ARCHITECTURAL REVIEW BOARD STAFF REPORT

Project #/Name	ARB-2021-49: Umansky Subaru Building Renovation
Review Type	Preliminary Review of a Site Plan and Architecture
Parcel Identification	04500-00-00-068D4
Location	On the west side of Routh 29 North, at the intersection of Hilton Heights Road and Route 29.
Zoned	Highway Commercial (HC), Entrance Corridor (EC)
Owner/Applicant	Umansky Properties TOC LLC/Design Develop LLC (Kevin Schafer)
Magisterial District	Rio
Proposal	The applicant proposes to renovate the Umansky Subaru showroom building by applying ACM (aluminum composite material) panels on portions of the Rt. 29 elevation and the majority of the Hilton Heights Road elevation, by painting the existing brick and EIFS gray, by adding elements to the south and east elevations including towers and canopy. The renovation proposal also includes additions to the rear (west) elevation.
Context	The Umansky Subaru site is located in the heavily developed Rt. 29 commercial corridor. The Subaru building is located just south of the Umansky Auto Park (previously Brown) building. A Walmart is located directly to the south across Hilton Heights Rd. Just beyond the Walmart is the Price Chevro

Figure 1: SDP2003-67 Approved Landscape Plan (Phase I)

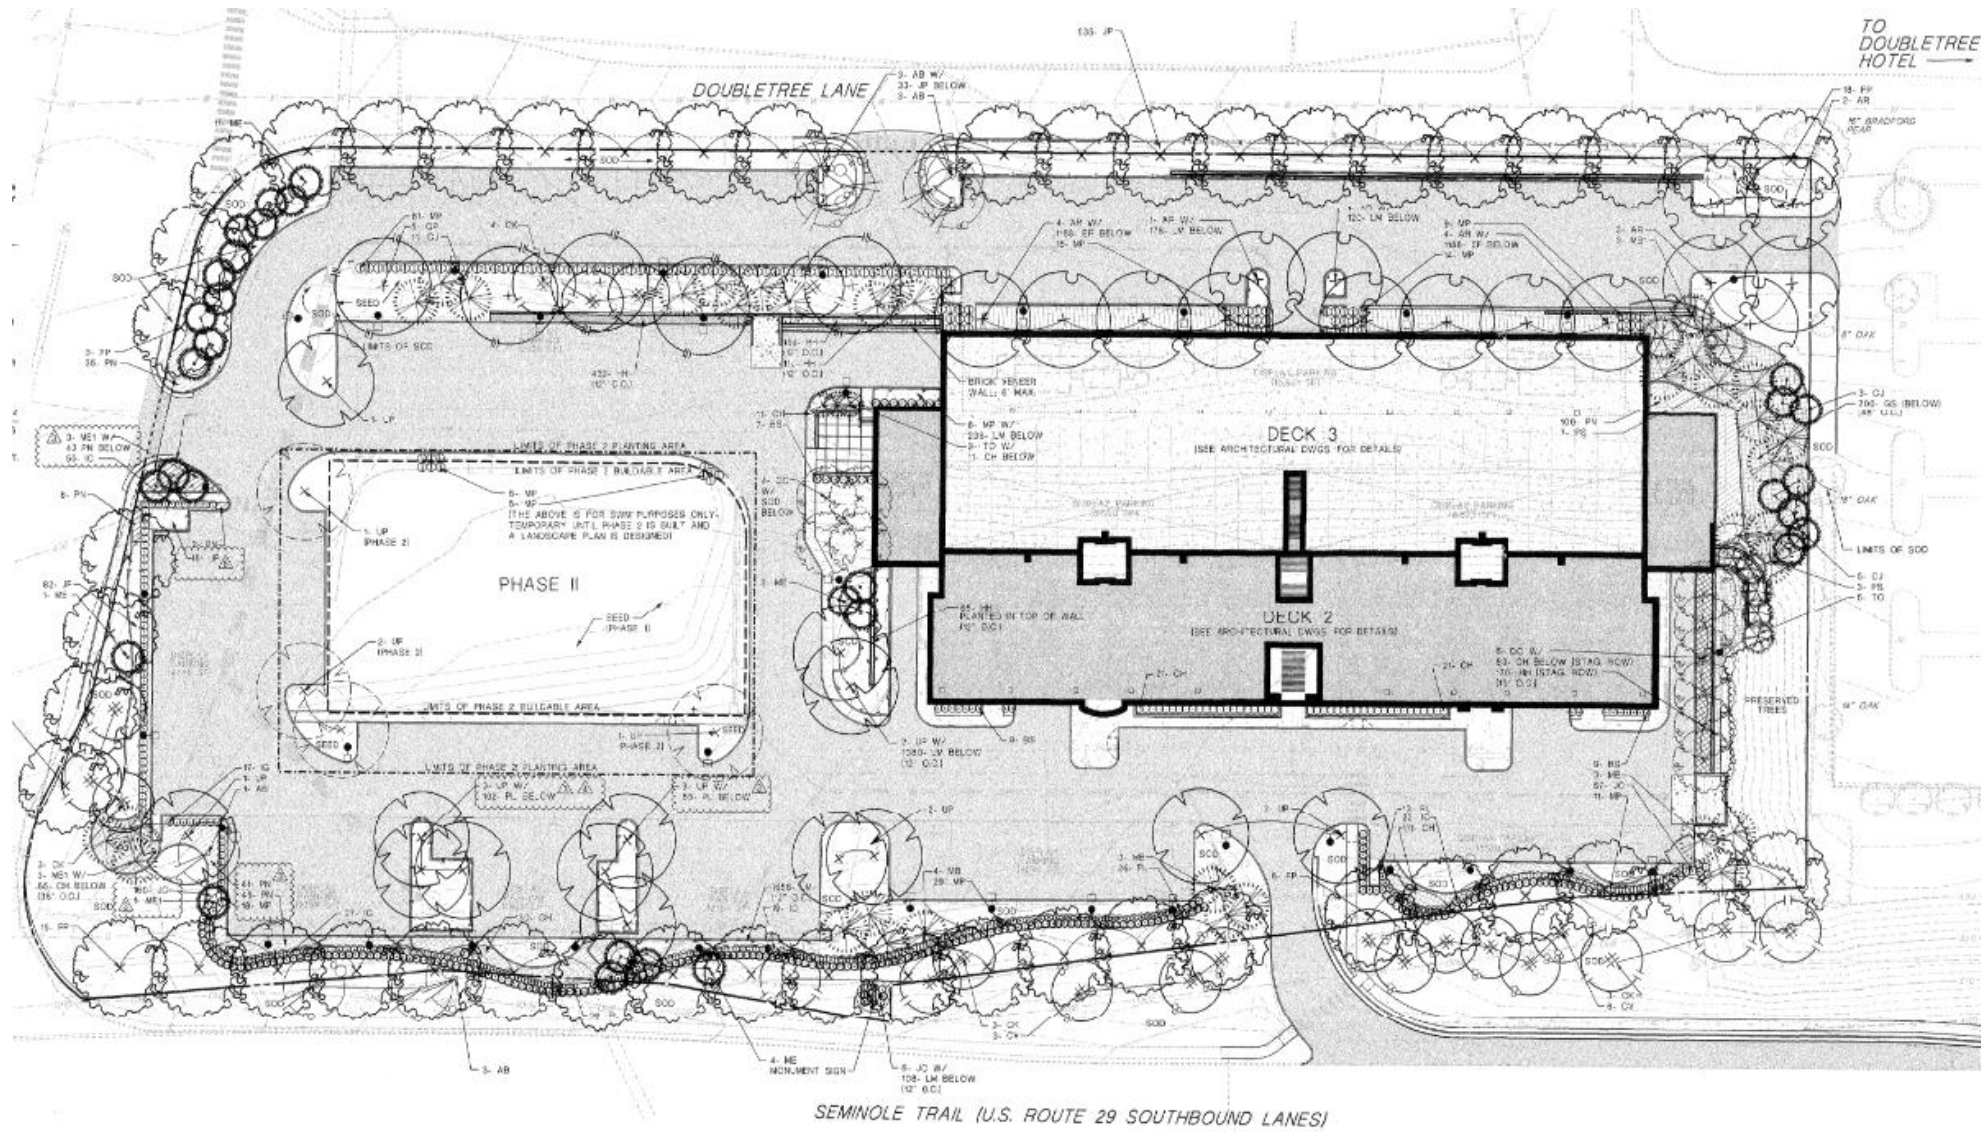
Landscaping	The landscape plan proposes a few changes to existing landscaping, and shows some, but not all, of the previously approved landscaping.	Revise the landscape plan to show all previously approved landscaping, and further clarify the proposal to identify plants to remain, plants to be removed, and plants to be added.
7	The requirements of the Guidelines regarding landscaping are intended to reflect the landscaping characteristic of many of the area’s significant historic sites which is characterized by large shade trees and lawns. Landscaping should promote visual order within the Entrance Corridor and help to integrate buildings into the existing environment of the corridor.	Established frontage landscaping is existing and is to remain in this renovation proposal.	None.
8	Continuity within the Entrance Corridor should be obtained by planting different types of plant materials that share similar characteristics. Such common elements allow for more flexibility in the design of structures because common landscape features will help to harmonize the appearance of development as seen from the street upon which the Corridor is centered.

5. Revise the landscape plan to show all previously approved landscaping, and further clarify the proposal to identify plants to remain, plants to be removed, and plants to be added.

Figure 2: SDP2005-45 Approved Landscape Plan (Phase II)

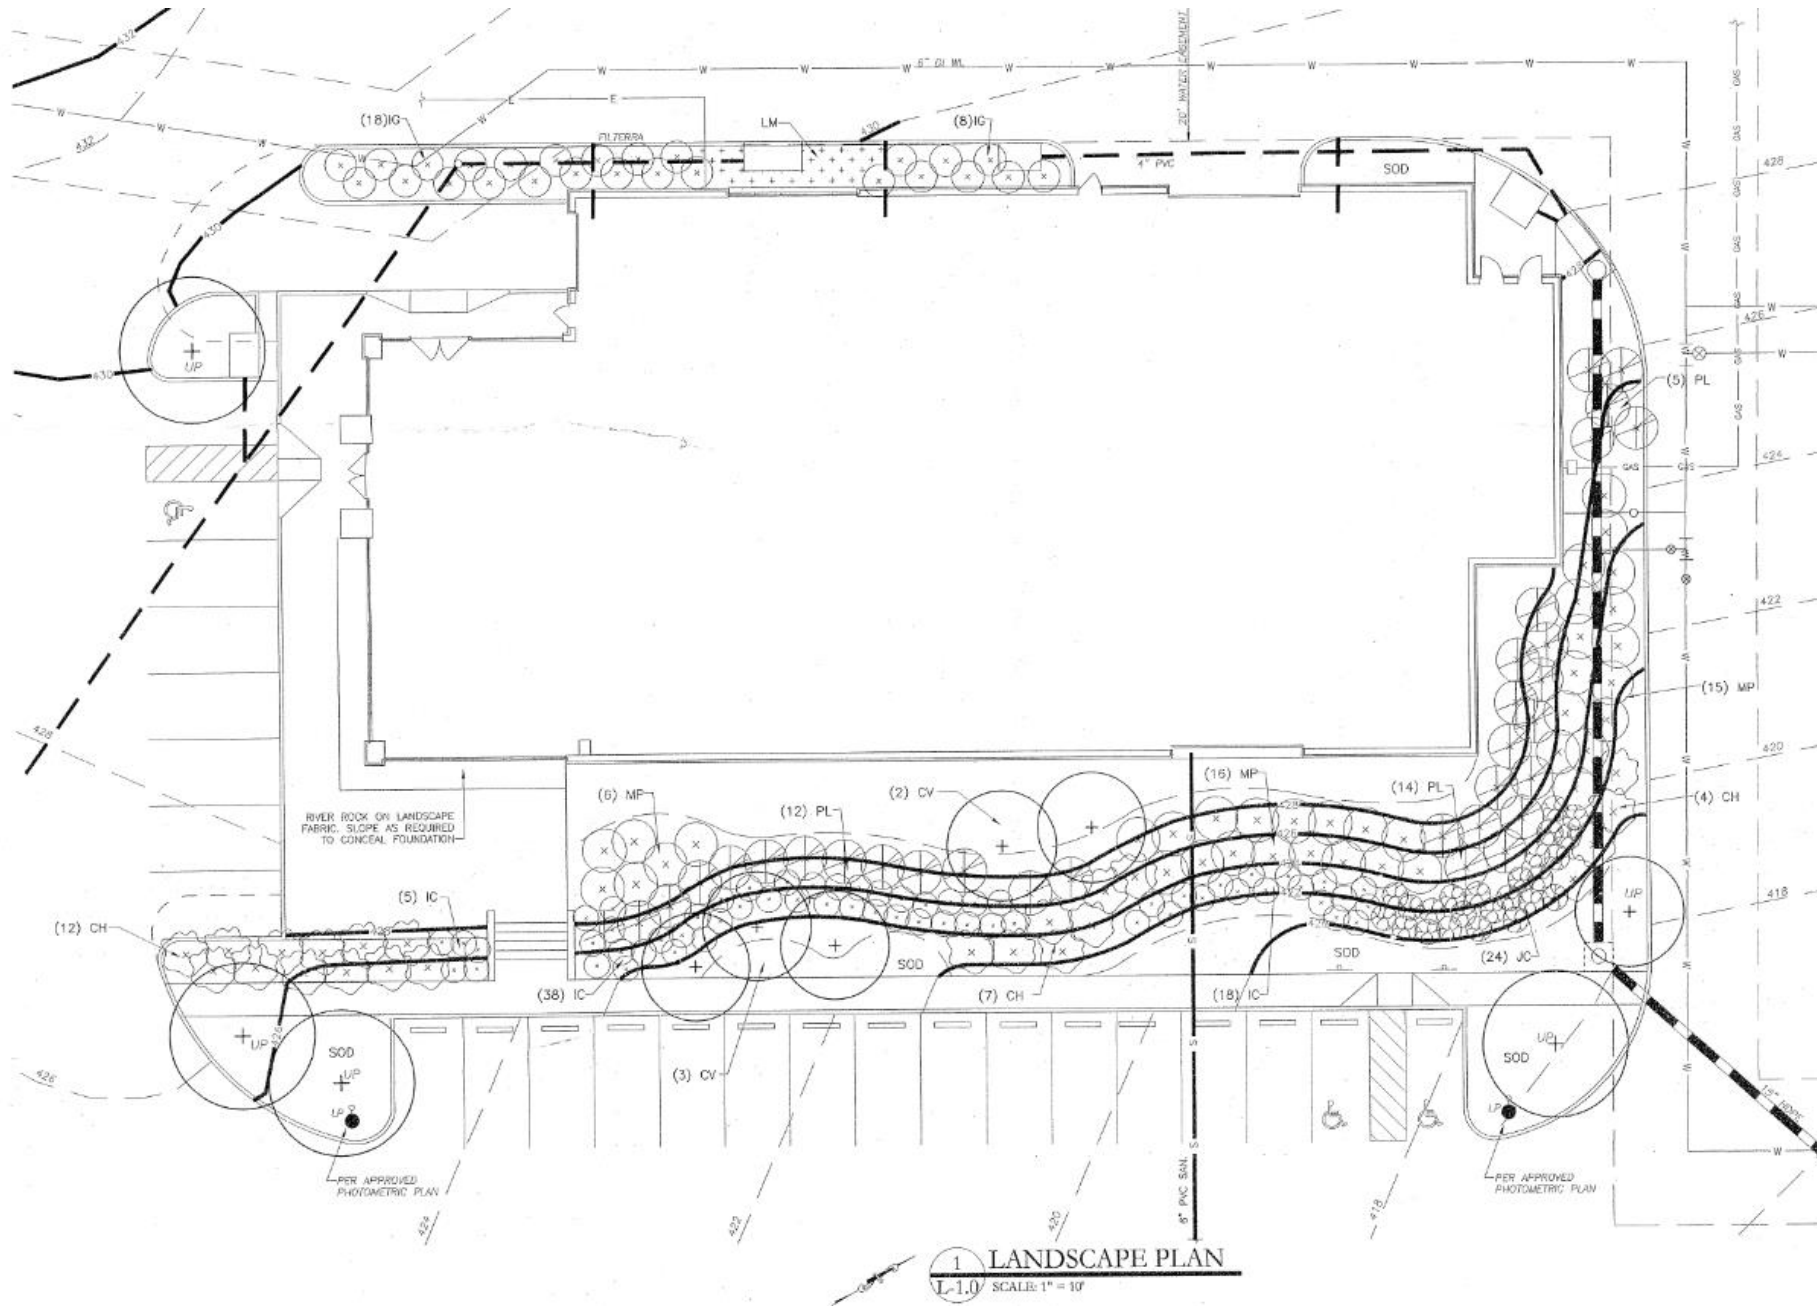
34	Landscaping along interior pedestrian ways: a. Medium trees should be planted parallel to all interior pedestrian ways. Such trees should be at least 2½ inches caliper (measured six inches above the ground) and should be of a species common to the area. Such trees should be located at least every 25 feet on center.	Other than the existing walkways along the east and south ends of the building, no interior pedestrian ways are proposed.	None.
36	Landscaping of buildings and other structures: a. Trees or other vegetation should be planted along the front of long buildings as necessary to soften the appearance of exterior walls. The spacing, size, and type of such trees or vegetation should be determined by the length, height, and blankness of such	The plan does not show all of the approved landscaping along the eastern end of the building. The approved landscaping successfully softens the appearance of the long extent of the exterior walls. Maintaining the approved landscaping is important in mitigating the	Revise the landscape plan to show all approved landscaping along the eastern end of the building.

6. Revise the landscape plan to provide show the correct quantity of shade trees along the parking area adjacent to Hilton Heights Rd.
7. Revise the landscape plan to show all approved landscaping along the eastern end of the building.
